CITY OF NORTHVILLE  
Planning Commission  
June 3, 2014  
Northville City Hall – City Council Chambers

**6. PRELIMINARY & FINAL SITE PLAN REVIEW: 481 SEVEN MILE ROAD**

DATE: 11/23/23  
 DRAWN BY: J. [Name]  
 CHECKED BY: [Name]  
 SHEET: CE-4

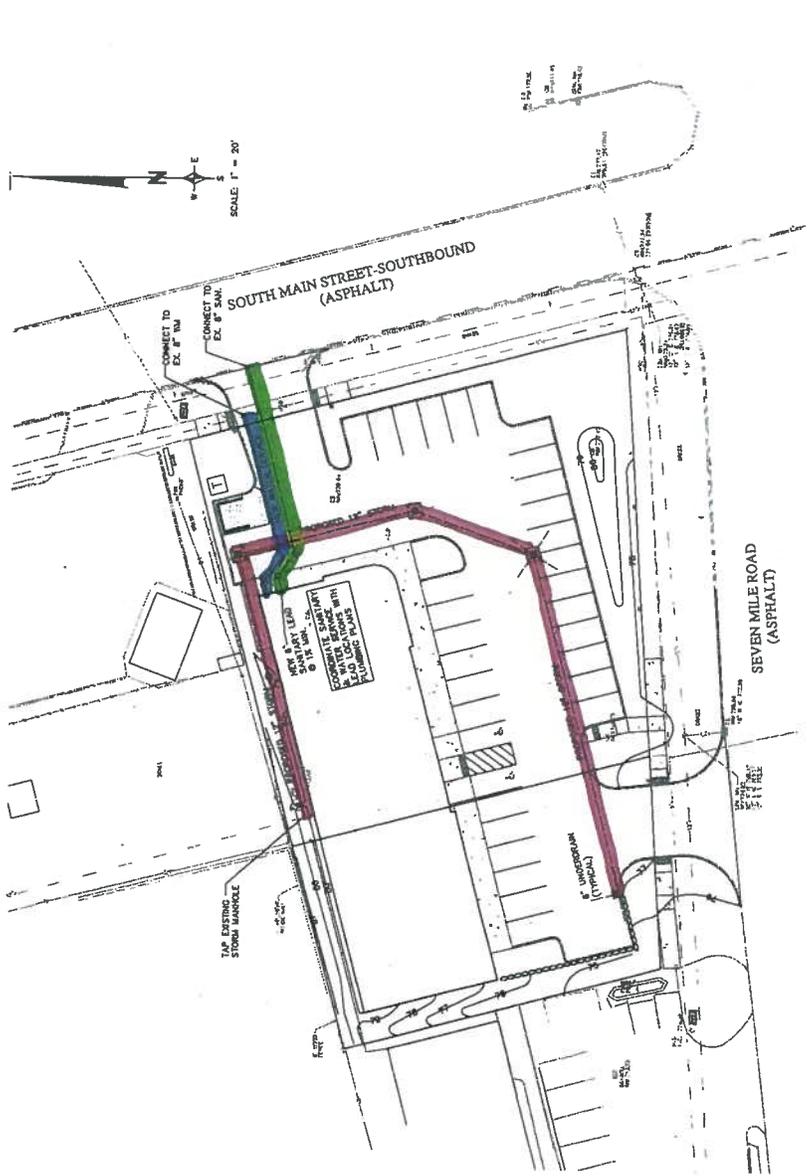
Mr. Mielock explained that the packet documents showed that the Applicants needed to retain water on site, build a holding tank, and direct water to flow to the drain in the Wayne County right of way on Seven Mile Road. However, since the documents were submitted, Director Gallogly had worked with the Applicants to come up with a different plan. Referring to a memo from Mr. Gallogly to the Commission dated June 3, 2014, Mr. Mielock explained that Mr. Gallogly had learned that the existing building had both sanitary sewer and storm sewer connected to an existing line which ran north to a 12” sewer in Gardner Street, then west to the Middle Rouge River. This line was originally labeled as a sanitary sewer lead, which is what the designer had used for a sanitary connection for the proposed building.

Questioning this sanitary connection, the Department of Public Works dye tested the line going north, and found that it ran directly to the river. Clearly this line could not be used for a sanitary sewer connection, but it could be used for storm water.

Based on this information, the applicants had modified plans for this project and designed both water and sanitary sewer connections to be made on the east side of the property in South Main Street. Storm sewer design was also changed, so that storm water was now designed to go into the City’s storm sewer system and not be connected into a Wayne County sewer on Seven Mile

Road. The change was significant because it reduced the amount of runoff going into the City's storm sewer. In doing this the applicants no longer had to retain and treat storm water on the site.

1. Parking requirement computations be based on applicant's request for office and retail use.
2. With reference to utility revisions for this site, the Commission accepts Sketch CE-4, dated 5-13-2014, with revisions as shown and attached to the memo dated 6-3-2014 from Public Works Director Gallogly and presented to the Commission this evening. This sketch will remain a permanent part of this motion.
